Access Compliance Report

Public Rights-of-Way

(Curb Ramps)

Intersection ID: 14014	Main Street: N_SHARON_AMITY_RD	Cross Street: WILORA_LAKE_RD	Location: NE
ADA ID: 79A4968D52B1	Ramp Type: Perp	Initial Pass/Fail: Fail	Overall Compliance: No
Severity Score: 21.25			
Codes/Mitigation Info/Possible Solution		Field Measurements/Component Compliance

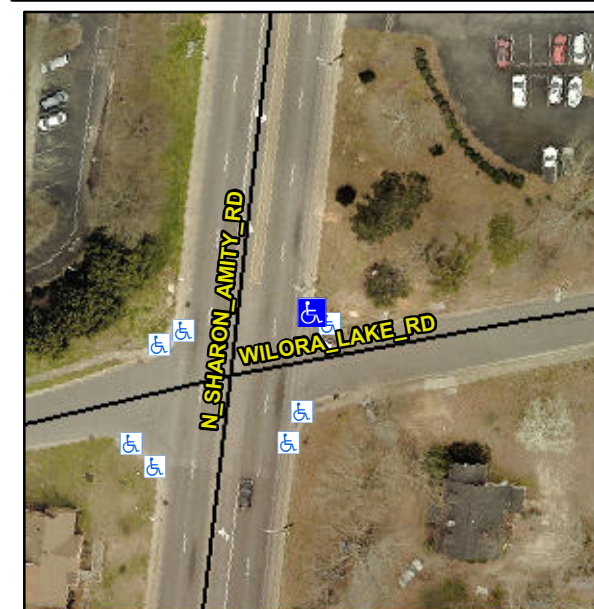
Not Found, R304.5.1, R304.2.2

Compliance	Description	Data	Compliance	Description	Data
N/A	Ramp Length (in)	58.5	No	Ramp Slope (%)	10.1
No	Ramp Width (in)	40.0	Yes	Ramp XSlope (%)	1.7
N/A	Flare Type LT	N/A	N/A	Flare Type RT	N/A
N/A	Flare Slope LT (%)	N/A	N/A	Flare Slope RT (%)	N/A
N/A	Flare Traversable LT?	N/A	N/A	Flare Traversable RT?	N/A
N/A	Landing Length (in)	N/A	N/A	DWS Provided?	N/A
N/A	Landing Width (in)	N/A	N/A	DWS Contrast?	N/A
N/A	Landing Slope (%)	N/A	N/A	DWS Length (in)	N/A
N/A	Landing X Slope (%)	N/A	N/A	DWS Full Width?	N/A
N/A	Landing Curb? (Y/N)	N/A	N/A	DWS Offset (in)	N/A
N/A	Shared Landing?	N/A			
N/A	Gutter Ponding?	Yes	N/A	Gutter Slope (%)	N/A
N/A	Gutter Lip Ht (in)	N/A	N/A	Gutter X Slope (%)	N/A
N/A	Painted X Walk1?	No	N/A	Painted X Walk2?	N/A
	X Walk 1 Direction	To W		X Walk 2 Direction	N/A
N/A	X Walk 1 Width (in)	N/A	N/A	X Walk 2 Width (in)	N/A
	X Walk 1 Slope (%)	2.3		X Walk 2 Slope (%)	N/A
	X Walk 1 X Slope (%)	1.2		X Walk 2 X Slope (%)	N/A

Remove & Replace Entire Ramp.
